Glenside Progressive Association (GPA)

Oral Presentation on Wellington City Council Proposed District Plan Hearing – Stream 6, Glenside West Supporting Notes, 22 Feb 2024

Fig 1A Upper Stebbings and Glenside West

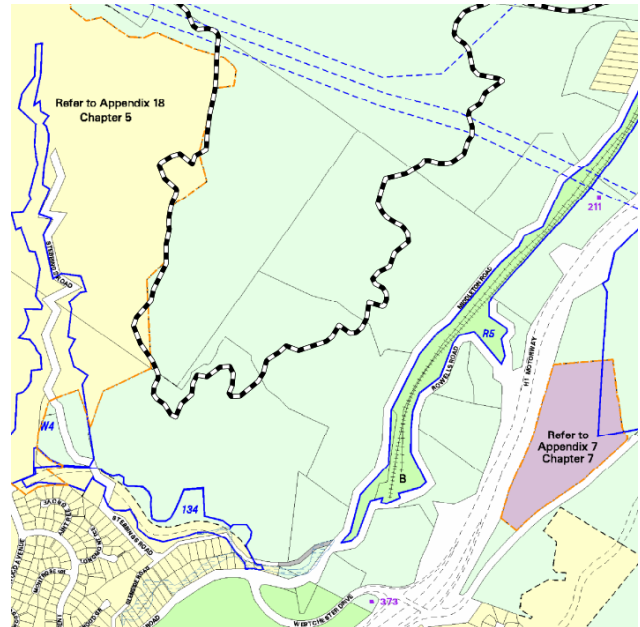
Figure 1A below shows the two proposed development areas. Glenside West is separated from Upper Stebbings Valley by a ridgeline, pine plantation and transmission lines offering no through access. There is no existing track connecting them and no possibility of a road link in future.

Glenside West will require a new high altitude road link to Farnworth Terrace and will be well beyond walking distance to the Churton Park shopping Centre and proposed bus routes. A new link to Westchester Drive (Te Kaha Road) would provide shorter road access to the motorway for residents of the new Reedy Block.

Conclusion: The proposed Glenside West development will be isolated and poorly connected. There are no remedies we can suggest to improve this.

Fig 3 Marshall Ridge

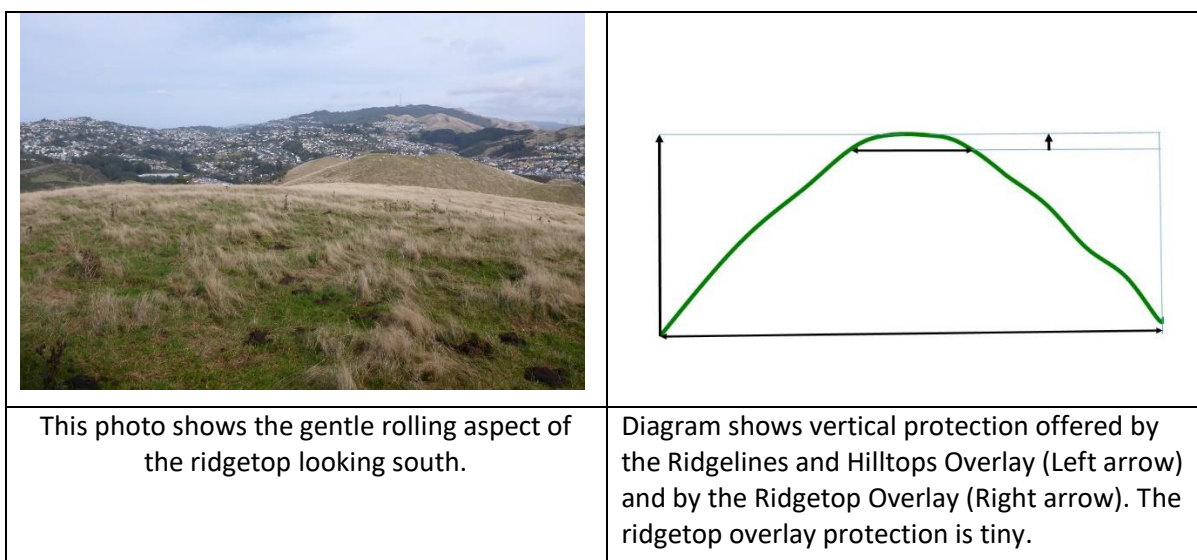
The limited visual protection now offered by the PDP will be ineffective as shown below.

Building close to ridgelines and can be costly and environmentally challenging, leading to erosion, damaging slips and uncontrolled storm water runoff. Ridgeline visual protection also acts as a constraint on such environmental impacts.

Fig 4 Glenside West development as proposed by Council and Developer respectively

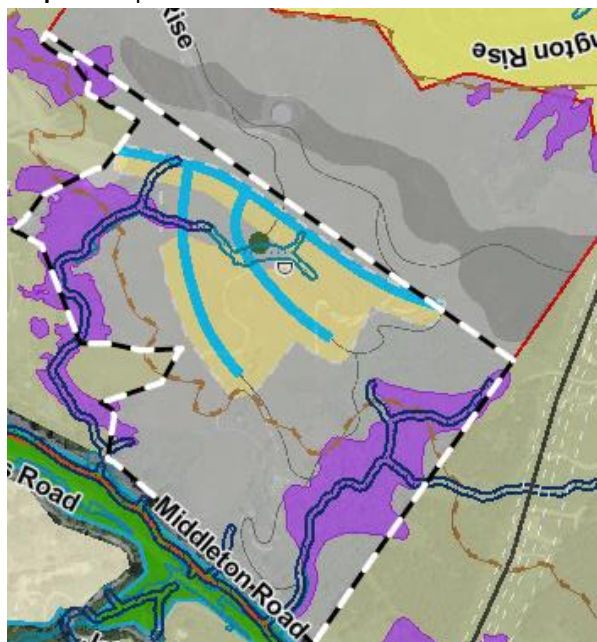
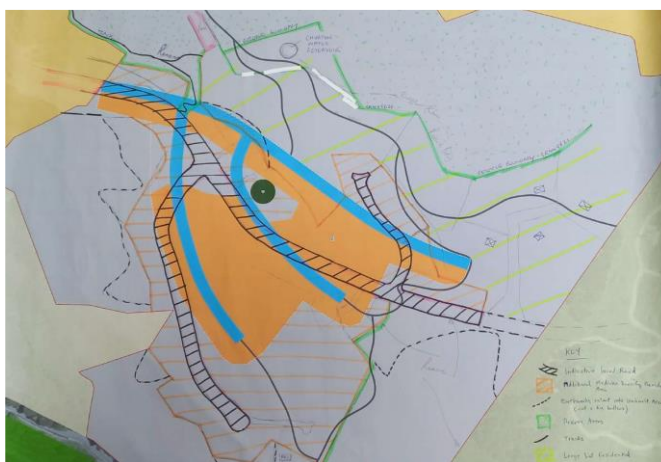
Fig. 4 below show what is proposed for Glenside West. Map A is the Proposed District Plan and the RH map Map B is the amended version sought by the developer, Stebbings Farmlands, primarily a change in the roading configuration and an accompanying increase in the area for development (orange hatch).

The plan is for MDRH within the part of Marshall Ridge earlier designated as part of the Ridgeline and Hilltop overlay. In both cases, housing is proposed to approach the crest of the ridgeline (Ridgetop) shown in dark grey. Housing constructed here will be very visible from nearby suburbs and SH1. Earthworks are likely to be extensive and gullies filled in. It is likely that the modified proposal by the Developer will result in more housing which will affect more land than Council’s proposal.

Remedy we seek: That the whole area shown in yellow or orange and light grey is limited to Large Lot Residential and that no housing is permitted above the upper black-white line in Map A. We are also strongly opposed to the filling in and piping of perennial and ephemeral streams, as shown in Fig 6.

Fig 6 Maps from Boffa Miskell report, 2018

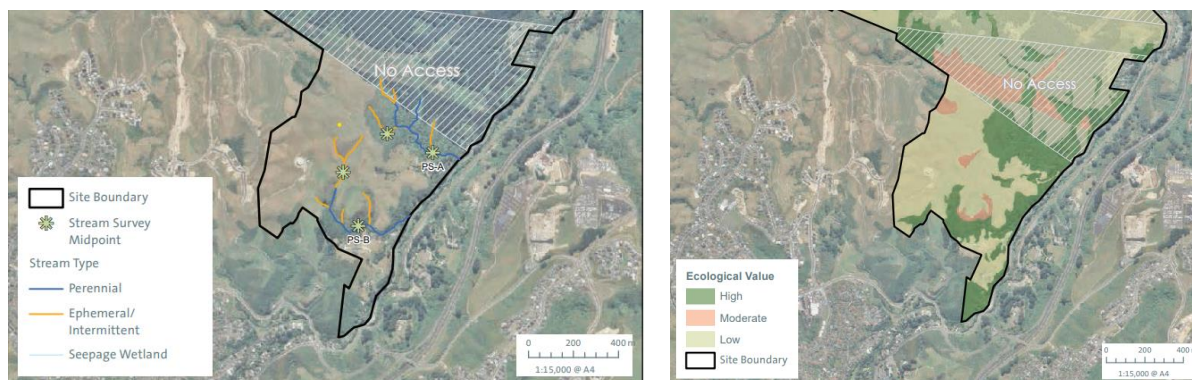
We reproduce two maps from their report, Fig 11 Streams and Fig 13 High Ecological Value respectively.

If any development is to take place, it is important that the lie of the land including gullies is accurately mapped, that these are not filled in during earthworks and that new roads are planned to avoid them. We note that Large Lot Residential in this area can be achieved using existing roads and driveways. Walking tracks could make use of existing farm tracks.

Remedy we seek: That any development in this area takes place with a minimum of vegetation clearance and earthworks, that no new roads are built and that natural gullies are not filled in.
